**PLANNING APPROVAL,
PLANNED UNIT DEVELOPMENT &
SUBDIVISION STAFF REPORT**

Date: October 7, 2010

<u>NAME</u>	Ashland Place UMC Subdivision 2
<u>SUBDIVISION NAME</u>	Ashland Place UMC Subdivision 2
<u>LOCATION</u>	5, 7 and 15 Wisteria Avenue, 2315 Old Shell Road, 2302 Dauphin Street and 2314 Dauphin Street (Southwest corner of Old Shell Road and Wisteria Avenue, extending to the North side of Dauphin Street, 87'± West of Wisteria Avenue, and 432'± West of Wisteria Avenue)
<u>CITY COUNCIL DISTRICT</u>	District 1
<u>PRESENT ZONING</u>	R-1, Single-Family Residential District
<u>AREA OF PROPERTY</u>	3 Lots / 4.6± Acres – Subdivision 1 Lot / 4.1 ± Acres – PUD and Planning Approval
<u>CONTEMPLATED USE</u>	Planning Approval to amend a previously approved Planning Approval to modify property boundaries at an existing church in an R-1, Single-Family Residential District, Planned Unit Development Approval to amend a previously approved Planned Unit Development Approval to modify property boundaries, and Subdivision approval to create three lots.

SITE PLAN

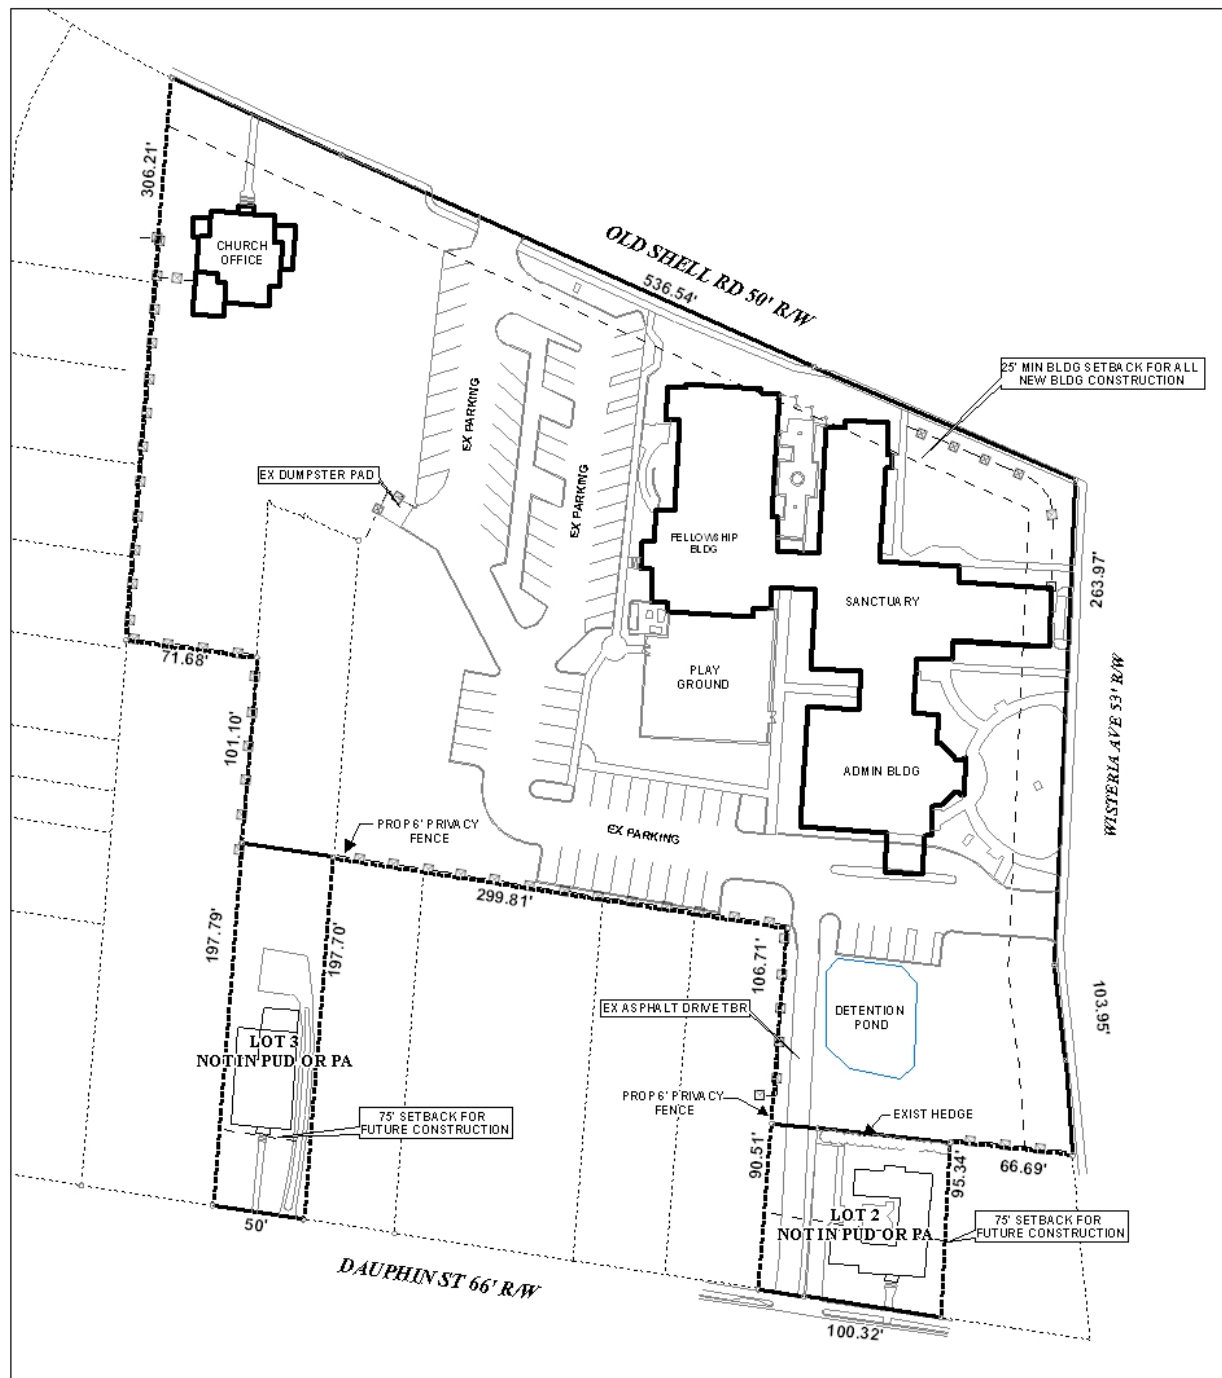
Some of the larger existing trees are depicted on the site plan, but trees planted as part of the most recent PUD and Planning Approval requirements are not depicted: these trees must also be shown. Also, it should be noted that any trees or shrubs planted to meet previous requirements, which have died, must be replaced.

A buffer fence is shown where the site abuts adjacent residences, with the exception of along the Southern boundary where there is an existing hedge, near the detention pond. The property owners at the location of the hedge have requested in writing that no fence be installed in the area of the hedge until such time as requested by the property owner. The site plan shows that the church's former drive to Dauphin Street, being sold to the adjacent property owner, will be blocked off with a wooden fence. A new buffer fence is also proposed to the Southwest, where the lot boundaries will be changed due to the Subdivision.

The PUD and Planning Approval site plans should also be changed to show the correct dimension next to the "driveway to be removed" and on the Southwest portion of the site.

Access management is a concern due to the presence of a proposed major street, and due to the church use located within a neighborhood. The church on Lot 1 should be limited to the two existing curb-cuts depicted on the PUD and Planning Approval site plans, while proposed Lots 2 and 3 should be limited to the single existing curb-cuts. Any changes to the curb-cuts for Lots 2 and 3 will require the approval of Traffic Engineering. Changes to curb-cuts on Lot 1 will require new PUD and Planning Approval applications.

- 1) Revision of the site plan to depict compliance with the tree and landscaping requirements of Section 64-4.E. of the Zoning Ordinance, including depiction of the full width of

- existing tree canopies that overhang street frontage areas, and provision of information regarding total landscape area and required front landscape area;

- 2) Depiction and provision of a 6-foot high wooden privacy fence along all boundaries where the site abuts adjacent residences (fence not to impact existing hedge), except within the minimum building setback along Wisteria Avenue and Old Shell Road, where the fence shall only be 3-feet in height, and the obtaining of permits to build any required new sections of fence;

- 3) Depiction of the tree buffering between the detention facility and the residential properties to the South, as part of compliance with condition # 1;

- 4) Revision of the site plan to show correct dimensions and bearings for all boundary segments;
 - 5) Application and receipt of a Land Disturbance permit, after the recording of the final plat, for the removal of the driveway paving, to include the submission of a new tree and landscape plan for the site;

- 1) Revision of the site plan to depict compliance with the tree and landscaping requirements of Section 64-4.E. of the Zoning Ordinance, including depiction of the full width of existing tree canopies that overhang street frontage areas, and provision of information regarding total landscape area and required front landscape area;

- 2) Depiction and provision of a 6-foot high wooden privacy fence along all boundaries where the site abuts adjacent residences (fence not to impact existing hedge), except within the minimum building setback along Wisteria Avenue and Old Shell Road, where the fence shall only be 3-feet in height, and the obtaining of permits to build any required new sections of fence;

- 3) Depiction of the tree buffering between the detention facility and the residential properties to the South, as part of compliance with condition # 1;

- 4) Revision of the site plan to show correct dimensions and bearings for all boundary segments;
- 5) Application and receipt of a Land Disturbance permit, after the recording of the final plat, for the removal of the driveway paving, to include the submission of a new tree and landscape plan for the site; and
